STAFF RECOMMENDATION 1606 Holly Street February 17, 2016

Application: New construction - infill
District: Lockeland Springs-East End Neighborhood Conservation Zoning Overlay
Council District: 06
Map and Parcel Number: 08314002900
Applicant: Preston Quirk, Quirk Designs
Project Lead: Melissa Sajid, Melissa.sajid@nashville.gov

Description of Project: The applicant proposes to construct a new two-story duplex and two single-bay detached garages at 1606 Holly Street.

Figure 1: 1606 Holly Street

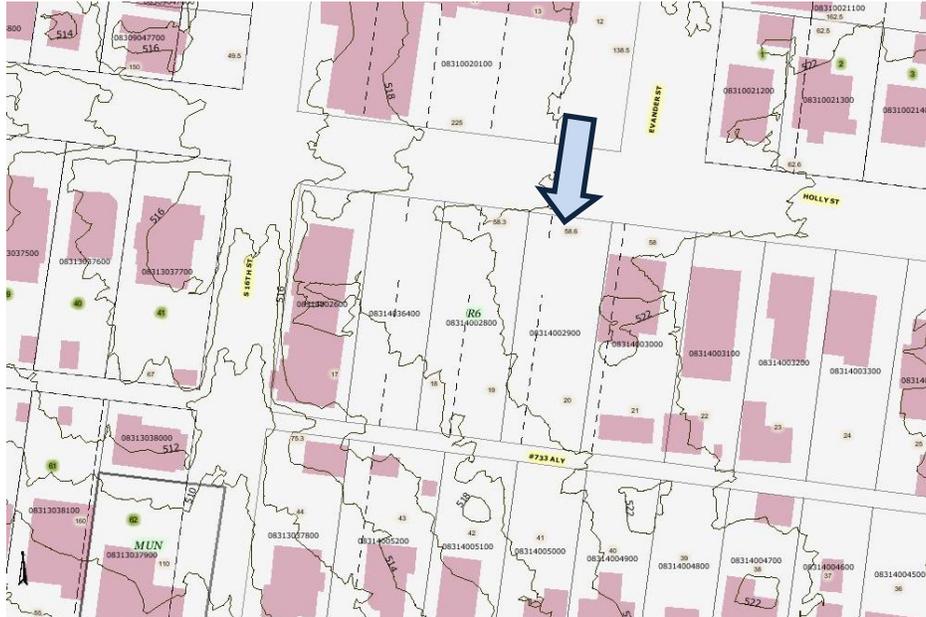
The new house will be one and a half (1.5) stories with a maximum roof height of thirty-two feet, six and one-half inches (32' 6 1/2") above grade, including a maximum two foot, four inches (2' 4") tall foundation at the front that varies with the slight change in grade on the site. The eave height will be twenty-one feet, three inches (21' 3") at the front. The height of historic houses in the immediate vicinity ranges from fourteen feet (14') to forty feet (40') tall. As the proposed infill is within this range, staff finds the proposed height to be appropriate given the context.

The new structure will have a maximum width of thirty-six feet (36') at the front setback and widens to forty-four feet (44') approximately twenty-eight feet (28') from the front setback. The proposed width is compatible with nearby houses, which range from thirty to forty-four feet (30' - 44') wide. In addition, most interior lots in the surrounding area are fifty feet (50') wide whereas this lot is fifty-nine feet (59') wide. As this lot is wider than other lots in the area, it is appropriate for the width of the house to be on the high end of the range of building widths.

Staff finds that the height and scale of the proposed one-and-a-half story house is compatible with surrounding buildings and meets Sections II.B.1 and II.B.2. of the design guidelines.

SITE PLAN

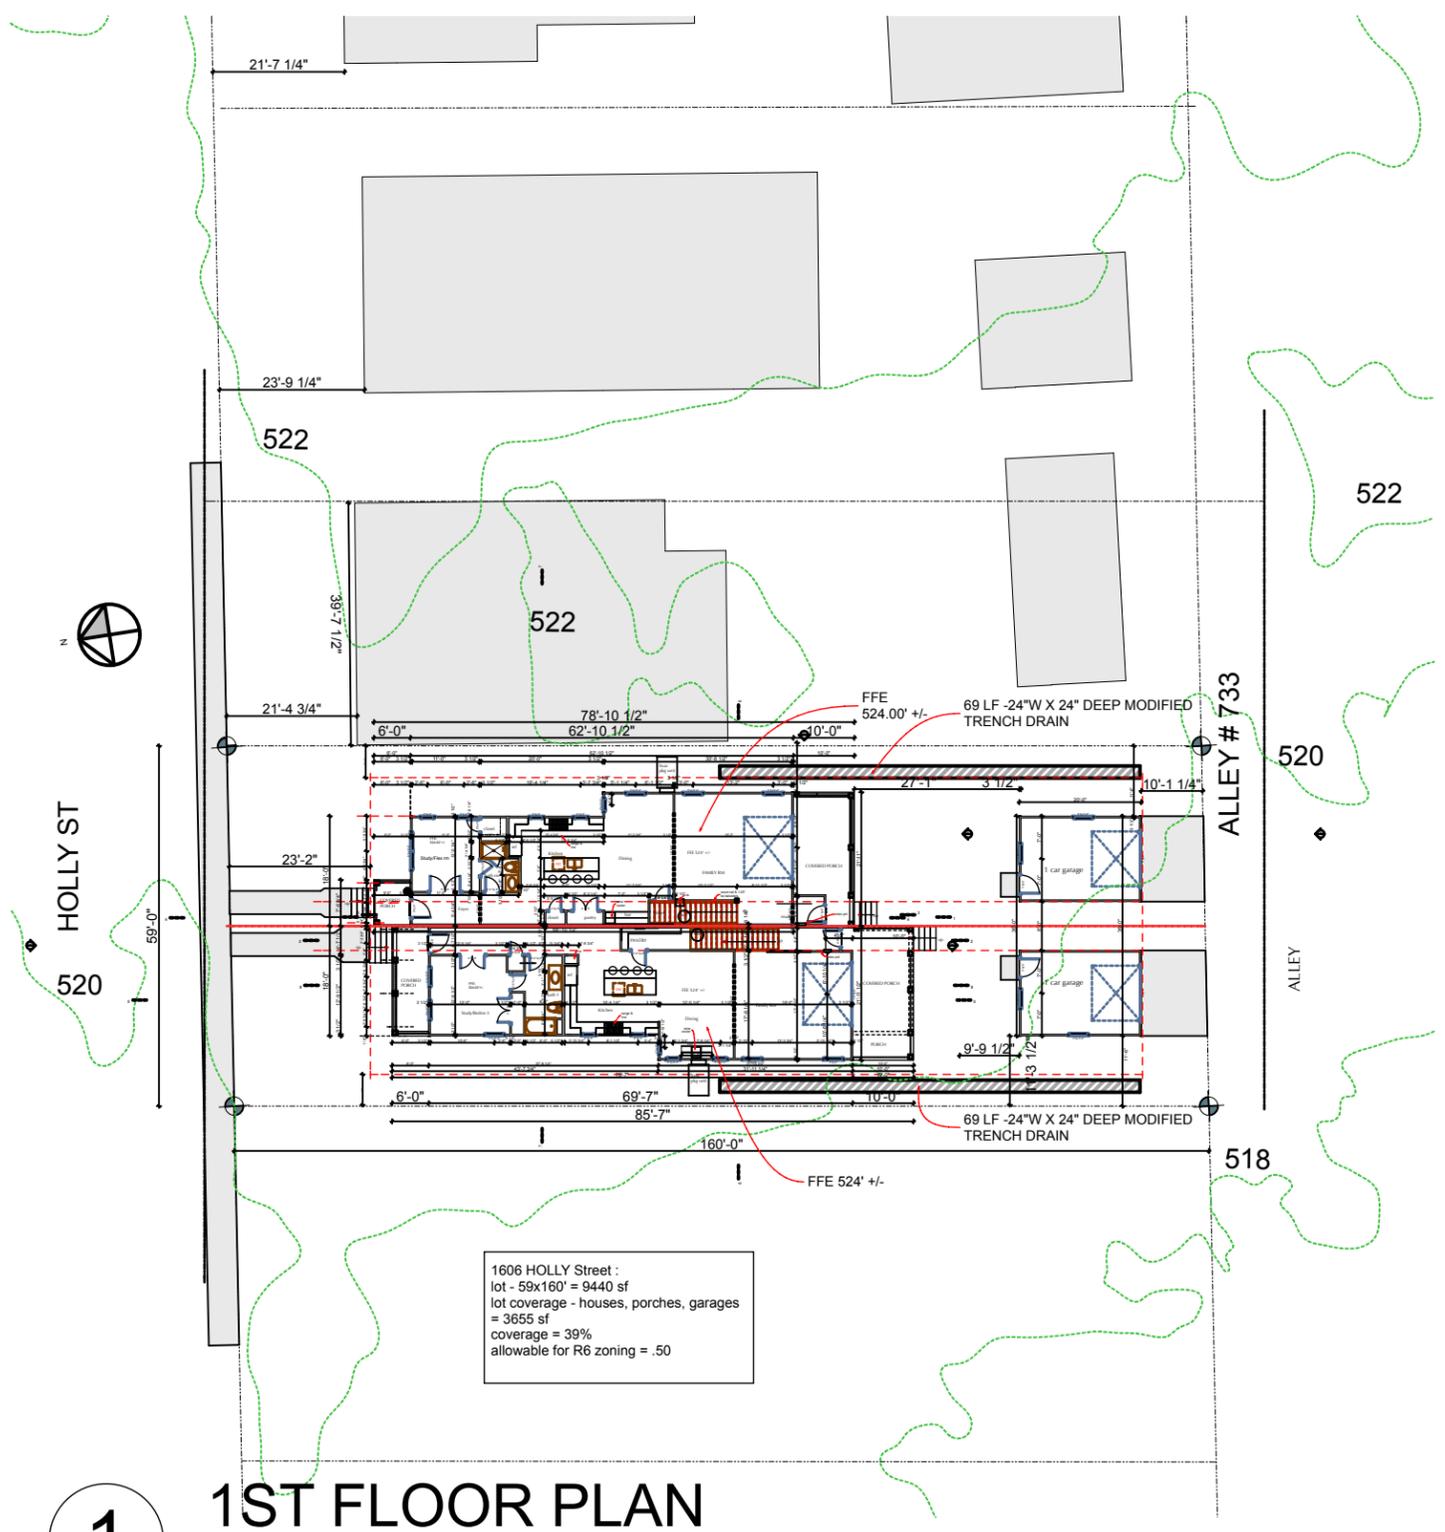
Setback & Rhythm of Spacing: The front wall of the infill will be located approximately twenty-nine feet, two inches (29' 2") from the front property line, and the porch for the left unit will extend out another six feet (6') into the front yard. The front setback of the existing contributing house to the left is approximately twenty-one feet, five inches (21' 5") from the front property line, and there is no house to compare to on the right as the

site is adjacent to a park. Staff recommends that the front setback of the infill be reduced so that it is consistent with the historic house to the left of the site. With this condition, staff finds that the proposed front setback is appropriate to the context. The side setbacks will be approximately seven feet (7') on both sides. This meets bulk zoning requirements and is consistent with historic homes in the immediate area.

- The front setback shall be reduced so that it is consistent with the historic house located at 1608 Holly Street;
- The finished floor height be consistent with the finished floor heights of the adjacent historic houses, to be verified by MHZC staff in the field;
- Staff approve the final details, dimensions and materials of windows and doors prior to purchase and installation; and
- Staff approve the roof color, dimensions and texture.

ELEVATIONS

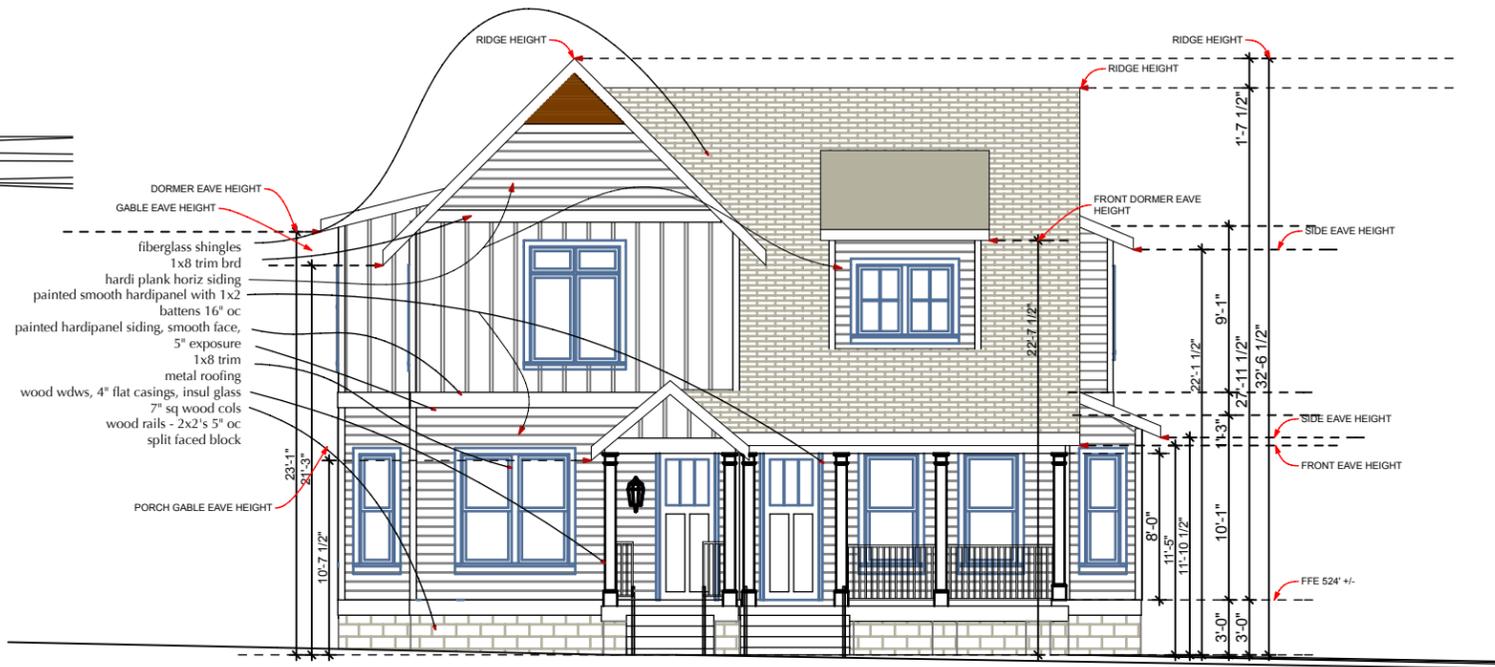
Materials: The exterior materials will include a split-faced concrete block foundation, smooth-faced Hardie plank siding, and a fiberglass shingle roof. The front façade also incorporates Hardie panel siding with batten strips as an accent on the front dormer and metal for the porch roof. The color of the roof is not known. The siding will have a five inch (5") reveal which is appropriate for the context. The exterior trim, including cornerboards, window casings, and porch columns will be wood. The porch floor is concrete. The materials for the windows is not known, so staff recommends a condition of approval that these are reviewed and approved prior to purchase and installation. Staff finds that the known materials of the proposal meet Section II.B.4. of the design guidelines.

Roof Shape: The roof will be cross-gabled with pitches of 8:12, 9:12, and 12:12 and includes shed dormers on the front and side façades that will be set off the ridge and inset at least two feet (2') from the wall below. The house also includes a two-story bay on the rear façade. These roof forms are compatible with those of surrounding houses. Staff finds that the infill meets Section II.B.5. of the design guidelines.

Rhythm and Proportion of Openings: The windows on the house will be generally twice as tall as they are wide, and the first story windows will be taller than those on the upper story, as seen historically. Paired windows have four to six inch (4"-6") mullions between them, also as seen historically. Staff finds that the proposal meets Section II.B.7. of the design guidelines.

GARAGES

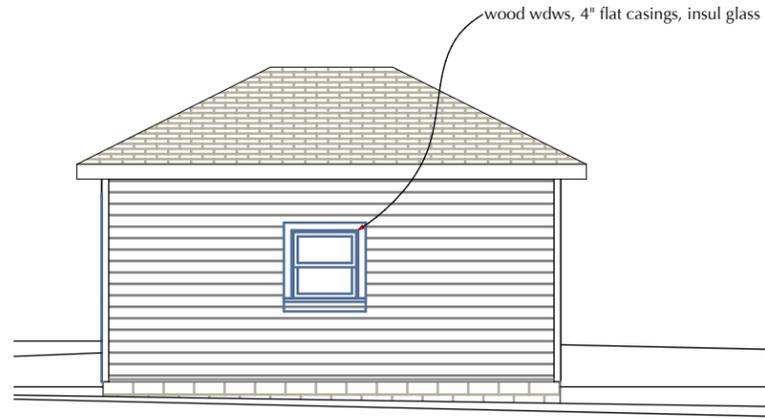
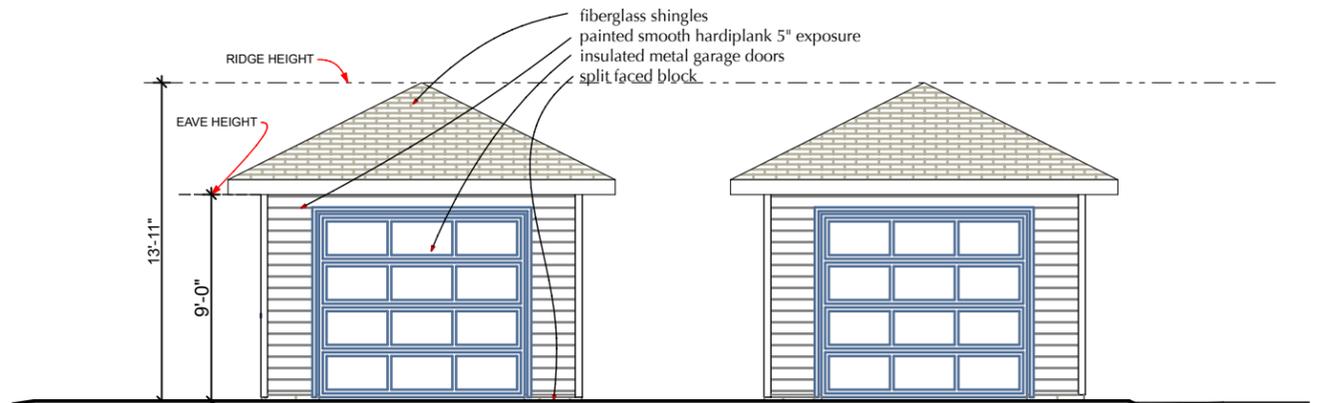
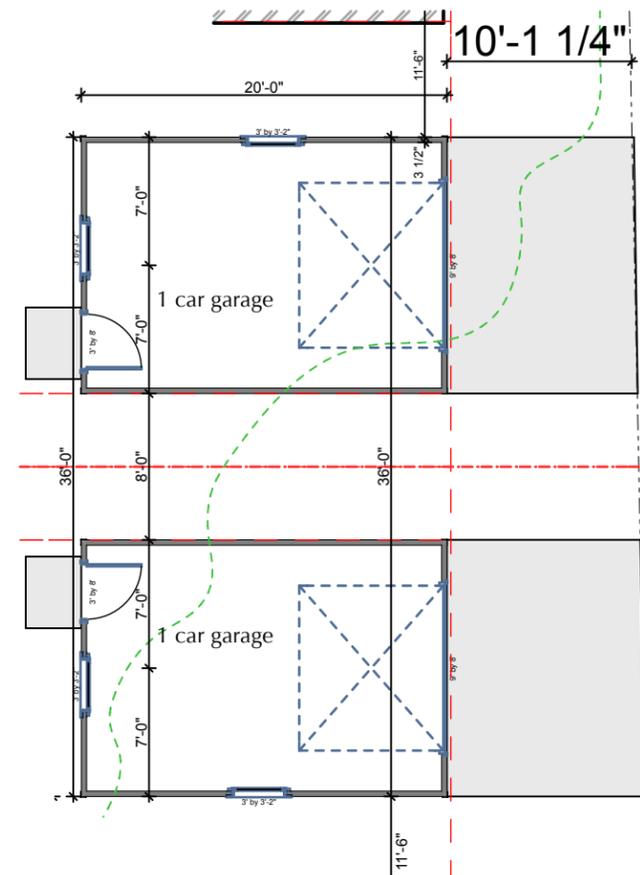
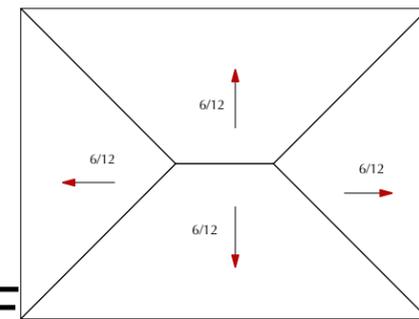
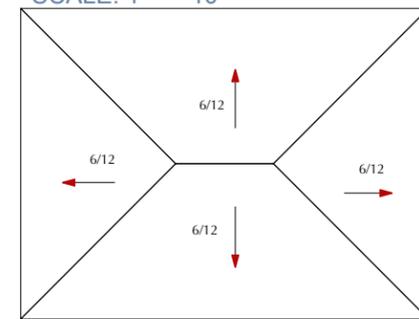
The plan proposes two single-bay detached garages, and the outbuildings meet the design guidelines for outbuildings. The outbuildings will be accessed via the alley, and each have a footprint of two hundred and eighty square feet (280 sq. ft.) for a total of five

The proposed materials are Hardie-plank siding with a reveal of five inches (5"). The roof shingles will be fiberglass shingles. The garage doors will be metal. The garage will sit on a concrete block. Staff asks to approve the final selection of door and windows.
